PLANNING REPORT

Administrative Review Team

Nestle Cafeteria Addition 26-062WID-DP

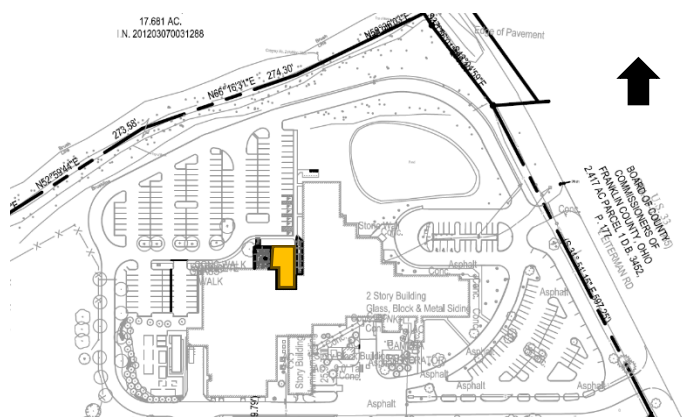
The applicant is proposing 2,635-square-foot cafeteria and associated site improvements on the north side of the existing building. The cafeteria is for employees and will not be public facing. The location of the addition is shown on the map below.

The building addition is proposed to replicate the existing design of the building. The addition is approximately 22 feet in height and will be clad with EIFS and masonry units with storefront windows and doors on the east and west elevations of the addition. Zoning Code considers EIFS to be a secondary material and not a primary material. However, a majority of the building is clad in EIFS as a primary material. An Administrative Departure is required to permit EIFS as a primary material for the addition. Two windows are proposed on the north elevation. The building addition meets all architectural requirements.
